**ON-SITE SEWAGE DISPOSAL SYSTEM
 HOWARD COUNTY HEALTH DEPARTMENT
 BUREAU OF ENVIRONMENTAL HEALTH**

Van Sant Plumbing & Heating IS PERMITTED TO INSTALL ALTER
 ADDRESS: 3 N Main Street, Mt Airy PHONE NUMBER: 1-800-682-6726
 SUBDIVISION: Fox Creek LOT NUMBER: 27
 ADDRESS: 12320 Fox Meadow Lane PROPERTY OWNER: NVR Inc.
 SEPTIC TANK CAPACITY (GALLONS): 1250 OUTLET BAFFLE FILTER REQUIRED
 PUMP CHAMBER CAPACITY (GALLONS): N/A COMPARTMENTED TANK REQUIRED
 NUMBER OF BEDROOMS: 4
 SQUARE FEET PER BEDROOM: 180
 LINEAR FEET OF TRENCH REQUIRED: 240 HOUSE SERVED BY PUBLIC WATER *Adj-3rd*
2410
-136
104 - still needed trench due to nearby 25% slope

WALL CHECK
 LOT 27
 FOX CREEK SUBDIVISION

NVHomes
FOX CREEK SUBDIVISION
LOT 27

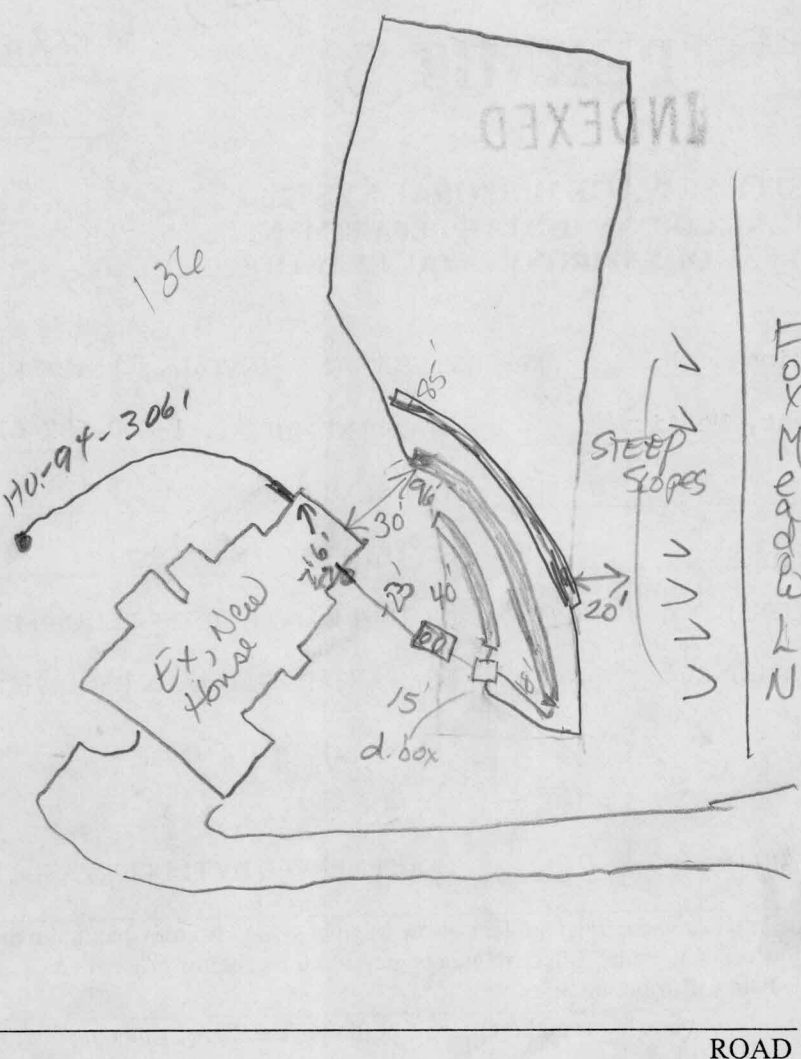
TRENCHES:	Trench to be 3.0 feet wide. Inlet 3.0 feet below original grade. Bottom maximum depth 5.0 feet below original grade. Effective area begins at 3.0 feet below original grade. 2.0 feet of stone below distribution pipe.
LOCATION:	Install the distribution box in the highest useable portion of the SDA. Maintain 25' from 25% slope due to road grade.
NOTES:	Maintain 9' edge to edge trench separation. Install a 40'/80'/60'/80' long trench on contour. <i>AS OF 8/1/03 40, 90 @ 3'-5' then 85 3-7</i> <i>revised by SO. on 7/28/03</i> <i>3rd trench revised by KN on 8/1/03</i>

PRE-CONSTRUCTION 7/20/03 SRA staked w/ out deletion. Measured to corner stay 20-25' off drop to road. Install 40' / 100' / 100' trenches.

INSTALLATION OK to relocate tank (SO) 8-1-03 house conn thru wall with 4" pvc cleanout. 3rd trench is 20' from 25' to slopes. 3rd trench specs change to bottom @ 7' for the 85' length which fits. Well radius not encroached upon. Checked soil profiles for 3rd trench adjustment. Adjust speed levels in dist. box for 1/3 more flow to 3rd trench. Water test with sanitarian present. OK to cover other two trenches. Measurement from shortest trench to house not taken due to huge soil mounds (KN)

8/4/03 ok to cover all work (SO)

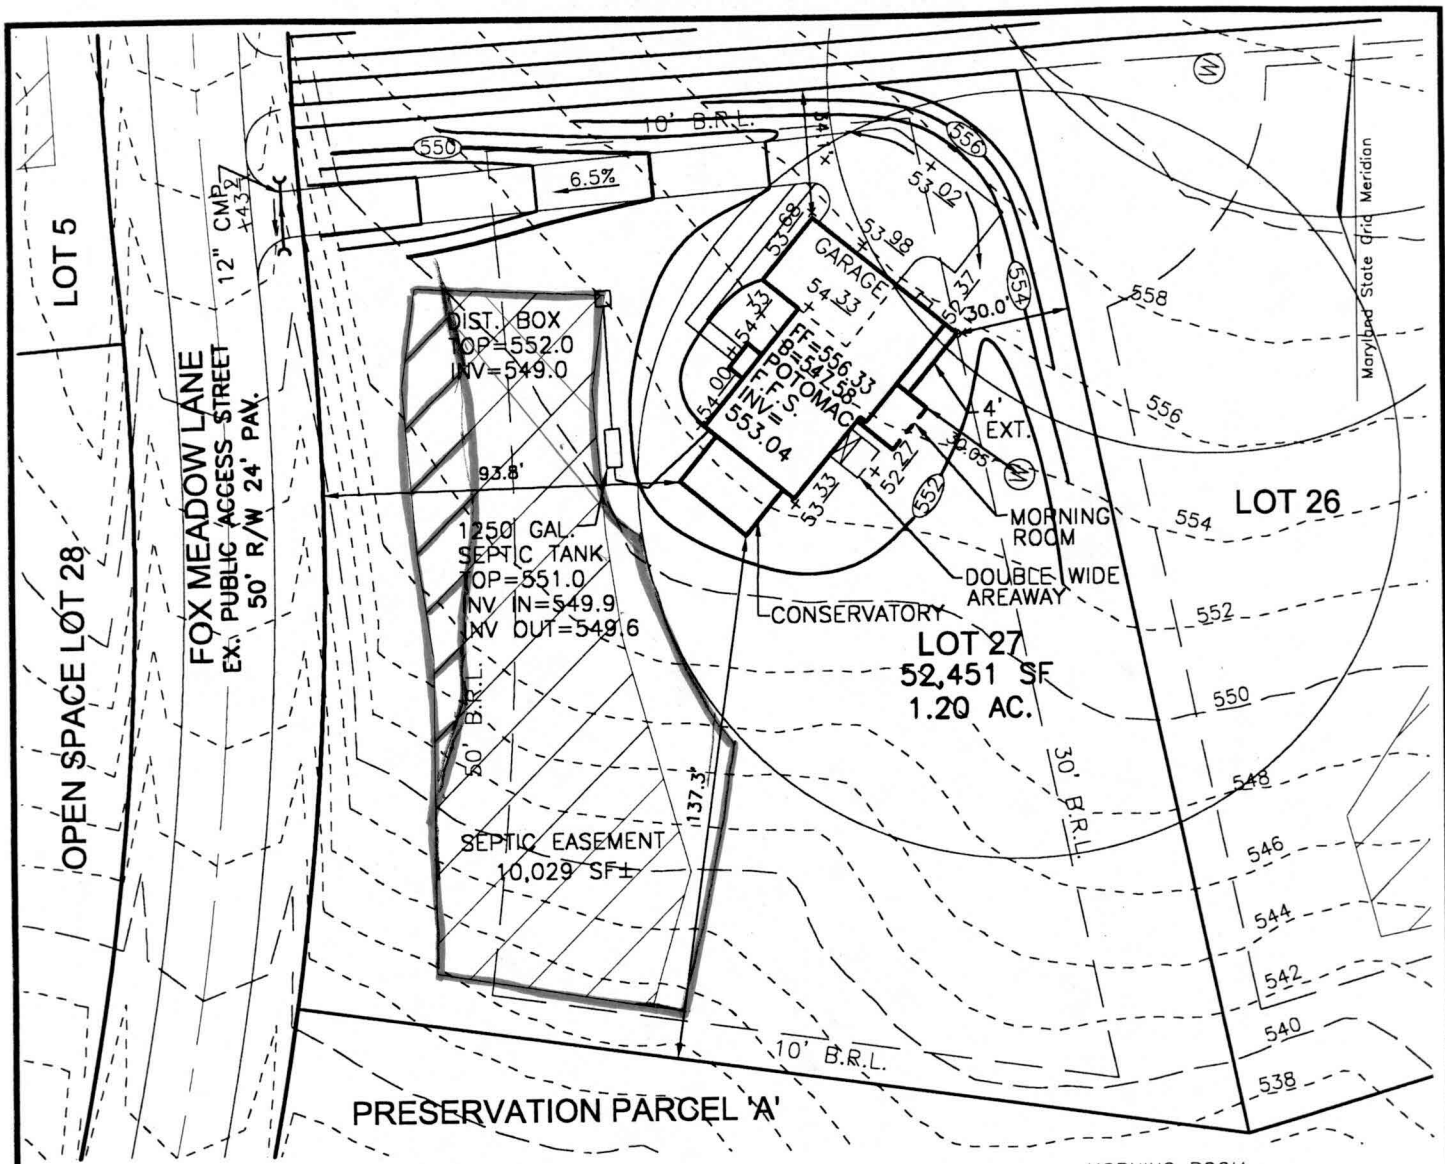
*2/9/03 House Raised
0.5' Should be*
